City of Maple Ridge
Advisory Design Panel
MEETING MINUTES
April 13, 2022 Regular Meeting

6.1 Development Permit No: 2021-281-RZ / 22936 – 22974 Dewdney Trunk Road

22936-22974 DEWDNEY TRUNK ROAD, 2021-281-RZ
 ADVISORY DESIGN PANEL (ADP) RESPONSE
 ISSUED FOR REVISED REZONING 2022-05-04

Old Design

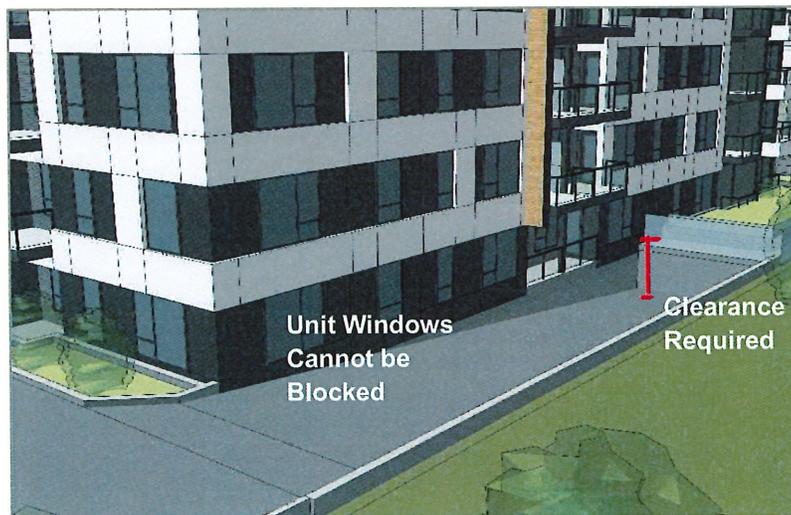
- Suggest enhancement of building access through landscape and architectural features

The lobby entrance has been redesigned to feel wider and more public. In front of the adjacent amenity room, the planter has been lowered and a new canopy feature with increased glazing has been introduced. Additionally, the newly lowered planter incorporates a building address sign.
